CERTIFICATE OF APPROPRIATENESS

Property: 1911 B Crockett St, Lot 5, Block 1, Barclay Estates Subdivision. The property is a vacant interior lot, subdivided into two lots, Lot A measuring 2,604 square feet (42' x 62') and the Lot B measuring 1,596 square feet (42' x 38').

Proposal: New Construction – Residence

PUBLIC COMMENT– Evan and Laura Michaelides

NORTH ELEVATION – FRONT FACING CROCKETT STREET

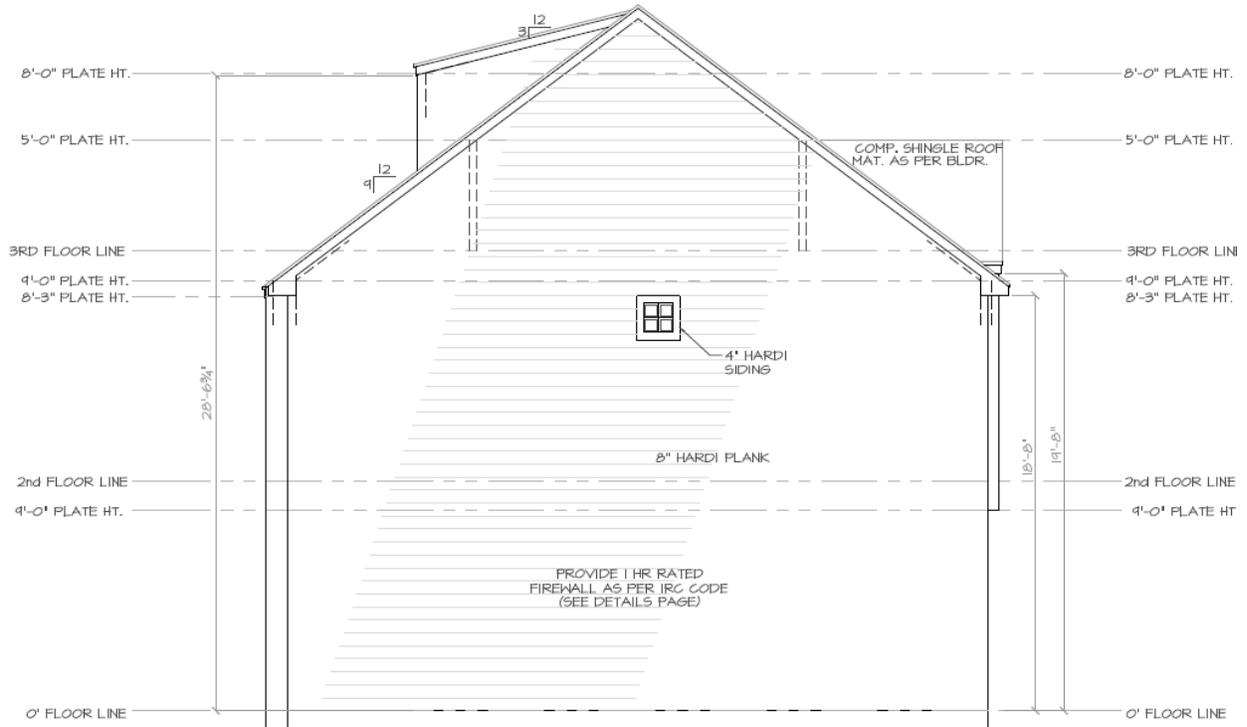
- 2.1. The contributing structures in the High First Ward Historic District include both single-story and two-story structures. However, it is not a random mixture; single-story structures are overwhelmingly prevalent. In fact, there are only two two-story contributing structures in the District: 1809 Summer and 2007 Shearn. Everything else is single-story. The overall proposal to add no fewer than five two-story structures in close proximity to each other is highly unbalanced and not compatible with the contributing structures in the District. Worse, the

existing historic structure at 1907 Crockett would be sandwiched in the middle of all this new construction which would loom over it, resulting in a classic example of what historic districts are intended to avoid.

- 2.2. In addition, several of the proposed structures (1911A, 1911B, 1913B) stretch the definition of what can be considered a two-story structure. By incorporating dormers (in order to capture additional living space in an area which in a traditional historical structure would be an unfinished attic), they create additional massing, worsening the contrast with and dwarfing of 1907 Crockett and the other contributing structures. These proposed new buildings are really two-and-a-half-story structures.

SITE PLAN
PROPOSED

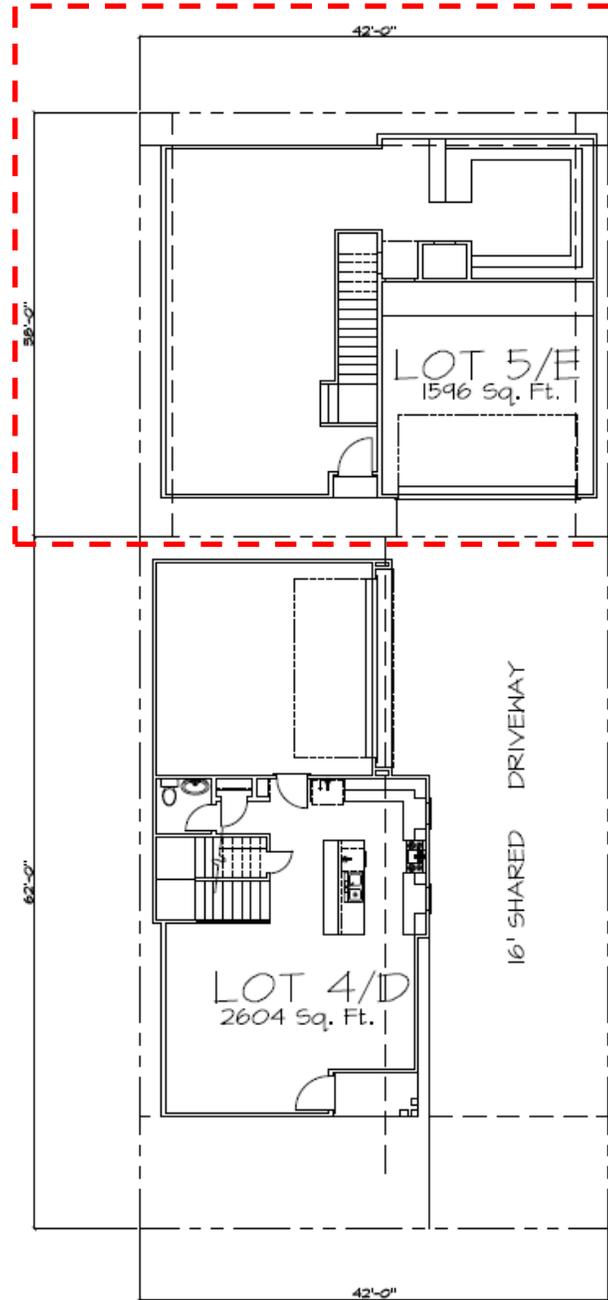
- 1.1. A site plan is required for a COA application. Each of these applications includes a drawing labeled "Site Plan". However, these purported site plans do not indicate the orientation of the proposed buildings to the surrounding streets or to each other. In addition, the elevations are listed as "left", "right", etc. instead of the usual "north", "south" etc. All this is contrary to industry standards, and makes the site plans very difficult to decipher. This needs to be addressed in order to make the proposed plans more readily understandable.

- 1.2. Given the close proximity and interrelationships of the proposed buildings with one another, a site plan should be provided that covers all the buildings in the project so that what is being proposed can be understood.

- 1.3. With respect to the applications for 1911A and 1911B Crockett: according to the records available online, the 5,000 square foot lot in question is platted into 3 lots, so one might have expected to see applications for 1911A, 1911B and 1911C. However, no COA application for 1911C appears to have been made. Are we to understand that the 5,000 square foot lot is being replatted into two instead of three, i.e., that 1911A and 1911B are going to take up the full 5,000 square feet? This is another point that the site plan should have made clear, but doesn't.

- 1.4. The historic/contributing structure at 1907 Crockett is known to encroach on its neighbor to the west (1913 Crockett). This encroachment is not shown on the site plan. This omission is significant, since it affects the actual distance that will separate the new structure at 1913 from the existing one at 1907.

- 1.5. A 10' setback from the street is noted. This is out of character for the District, where setbacks of 15 feet or more are prevalent on contributing structures. Is this permissible?
